TECHNICAL BULLETIN

[Issue No.] GOT-A-0105-A

[Title] Changing the Ethernet Interface for the GOT2000 Series/GOT1000 Series Multimedia Unit

[Relevant Models] GOT2000 series/GOT1000 series multimedia unit (GT27-MMR-Z, GT16M-MMR)

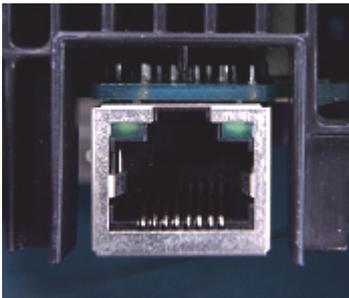
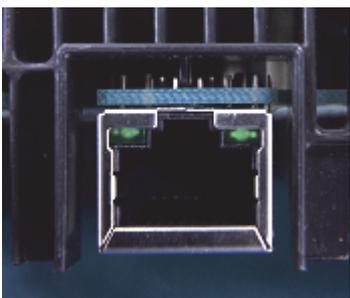
The appearance of the Ethernet interface of the multimedia unit is changed.
